INSPECTION REPORT  
Sedimentation Structure  
N14-P  
Kayenta Mine  
Navajo County, Arizona  
for  
PEABODY COAL COMPANY

Dames & Moore  
10139-011-22

SITE PLAN  
N14-P

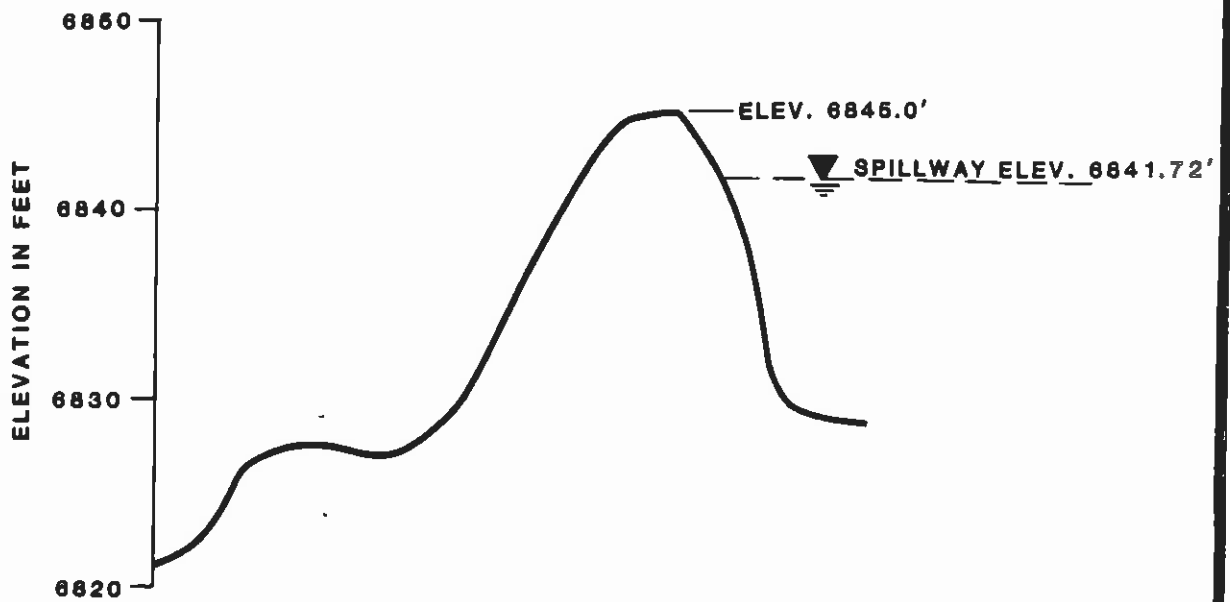
The storage capacity and spillway capacity of Structure N14-P are adequate; however, the spillway does not have an adequate outflow channel or adequate erosion protection. A trapezoidal outflow channel should be constructed along the alignment B-B' shown in Plate 1. The channel profile is shown in Plate 4 and the required dimensions are shown in Plate 5. Both the spillway and outflow channel should be protected against erosion using geotextile and gravel as shown in Plate 5.
